# CITY OF CONCORD

### **Project Summary – Minor Subdivision**

Project: Concord Monitor – Minor Subdivision (2019-58)  
Property Owners: Newspapers of New Hampshire, Inc.  
Address: 1 Monitor Drive  
Map/Block/Lot: 12/P1

**TO:** Sam Durfee, Senior Planner  
**FROM:** Bryant A. Anderson, PE  
**DATE:** November 5, 2019  
**SUBJECT:** Plan Review, Subdivision, Concord Monitor, 1 Monitor Drive;  
Map 12P, Lot 1; (2019-60)

# Whitney Road Mapped Line of Future Street

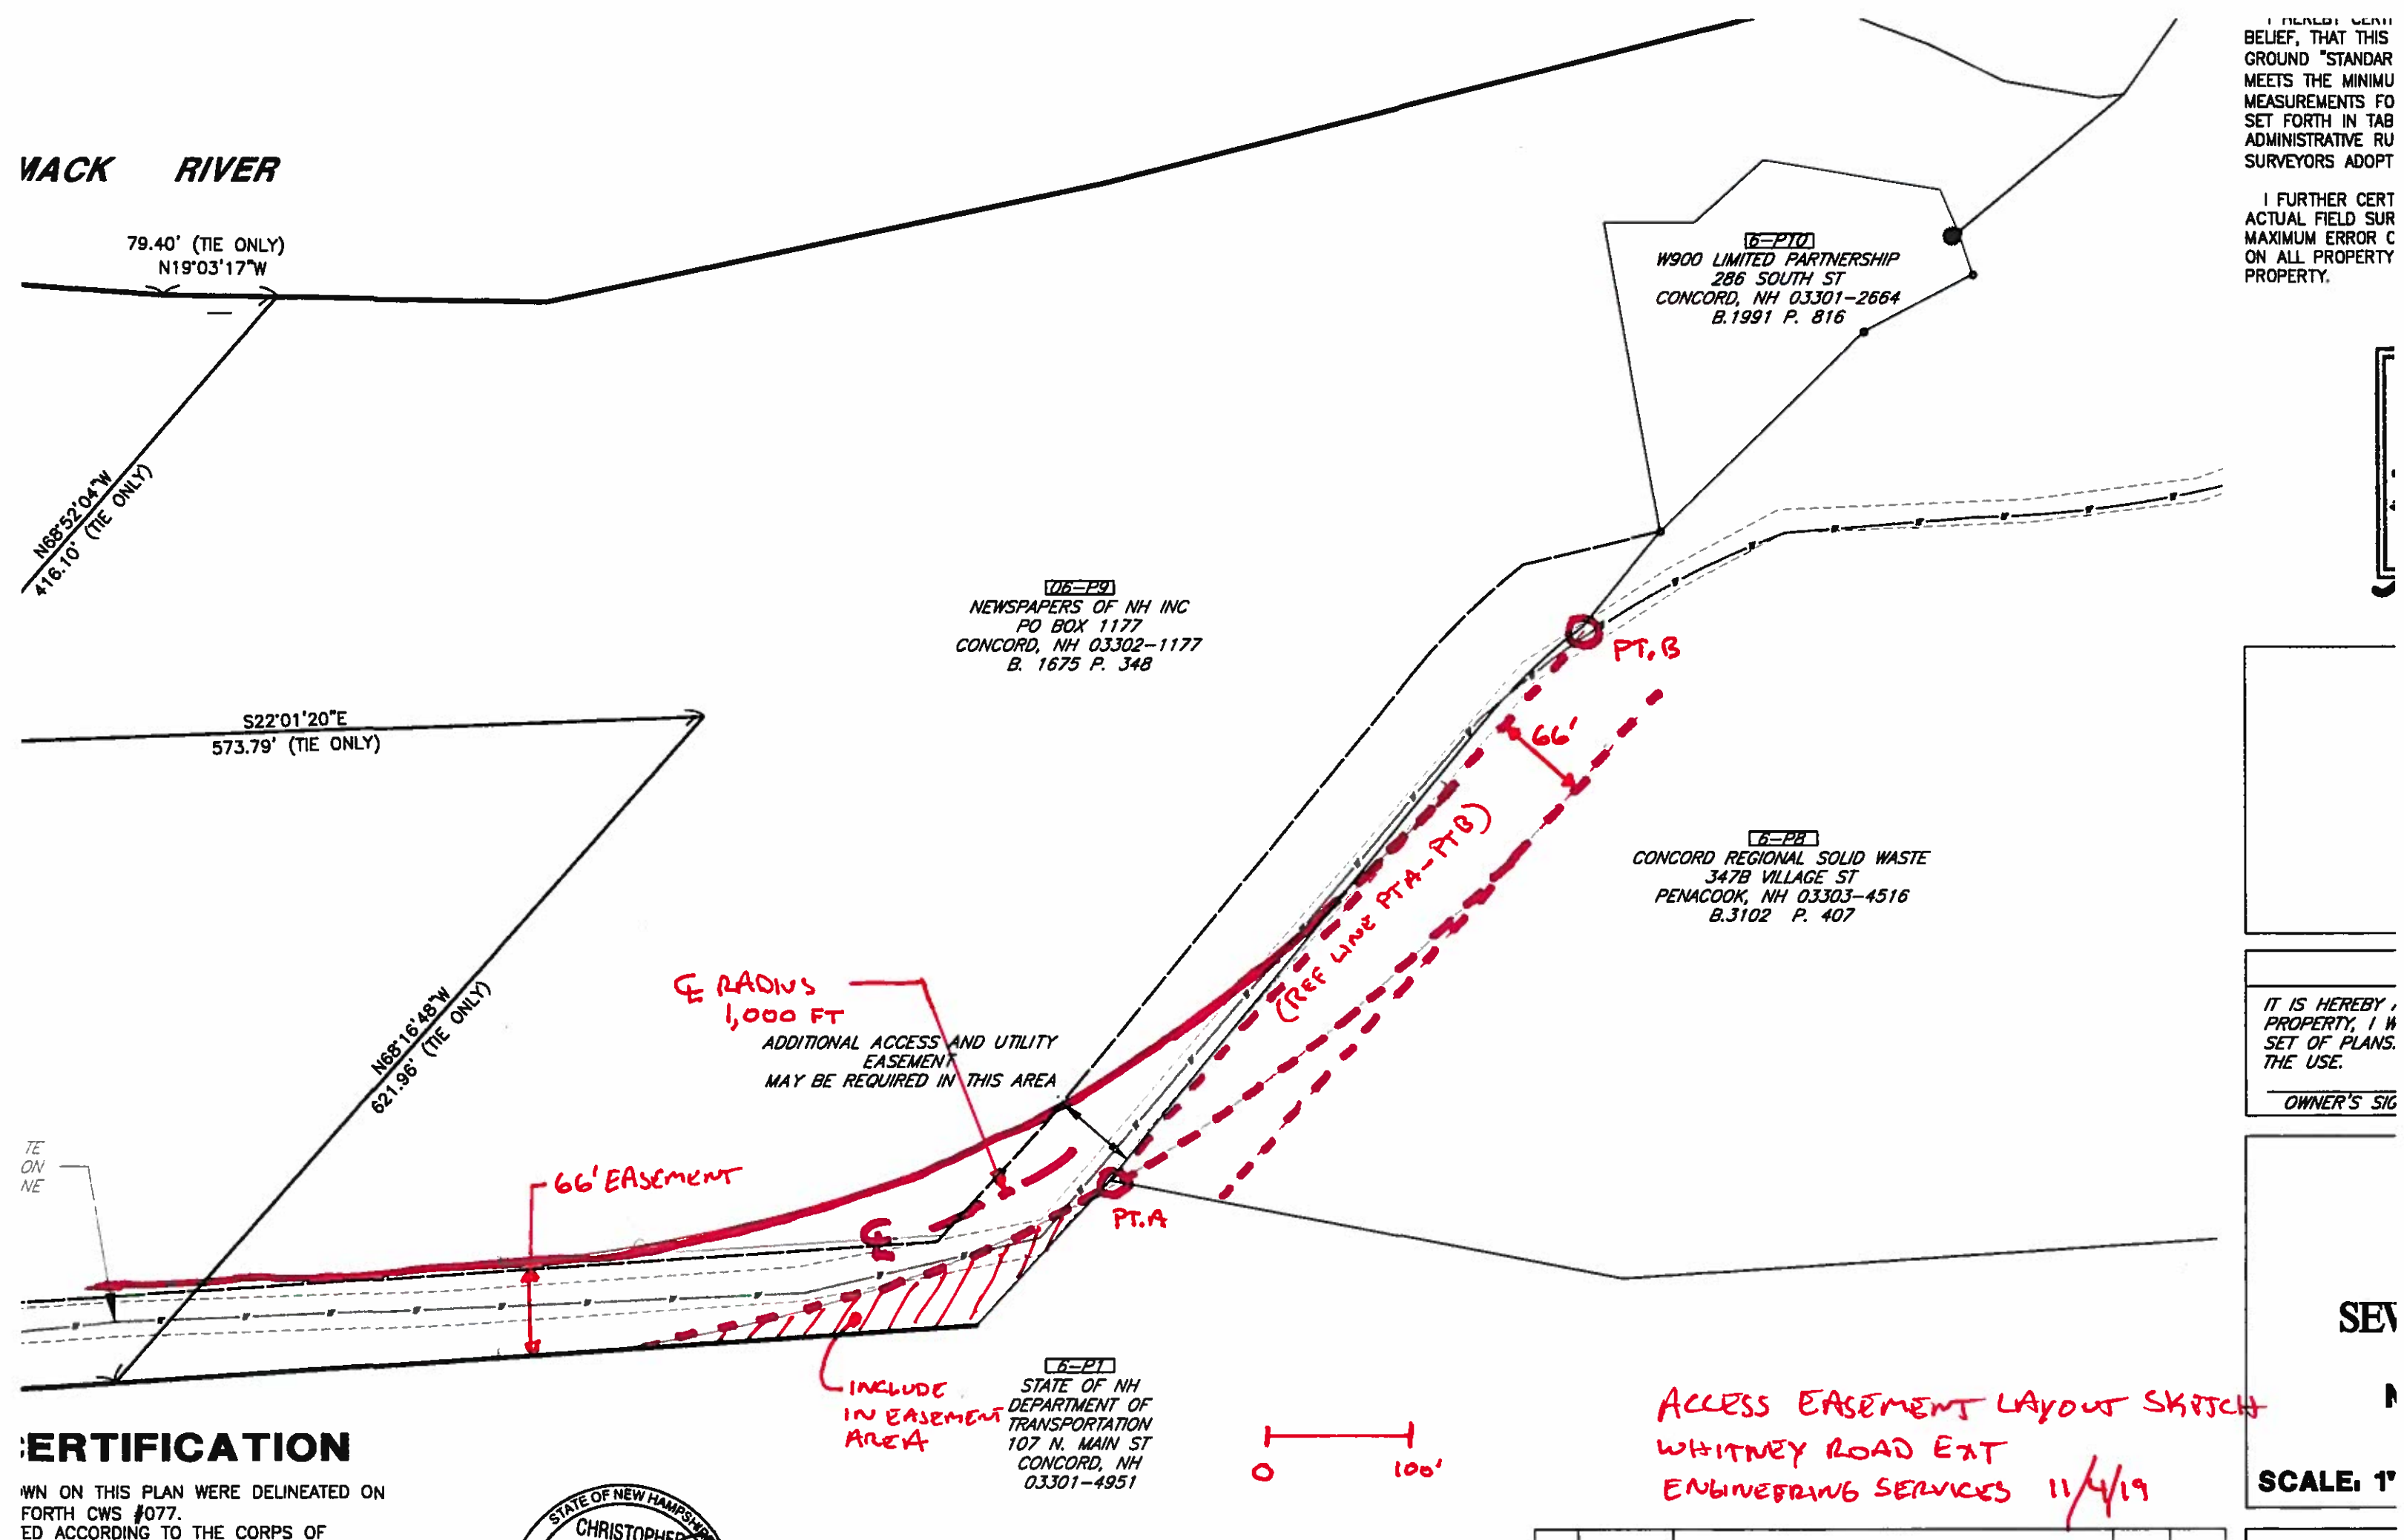
1. The proposed 60' Access Utility Easement shown on the plans should be labeled Public Highway Right-of-Way Easement and the width should be increased to 66 ft. wide in accordance with the Planning Board's and City Council's 2013 decision to establish a mapped line of future street for Whitney Road. In addition, the following should be provided:
  - a. The easement area needs to be excluded from the existing and proposed lot areas,
  - b. A public highway right-of-way easement deed and plan will be necessary. It is our understanding that an example easement deed was previously provided to TFM.
  - c. The abutting lot (06P/9) is also owned by Newspapers of New Hampshire, Inc. and has no legal lot frontage. In order to facilitate providing frontage in the future, Engineering recommends that a ROW easement should be provided over this lot as

part of this application. An easement layout sketch and a figure of the mapped ROW line are attached to this memorandum.
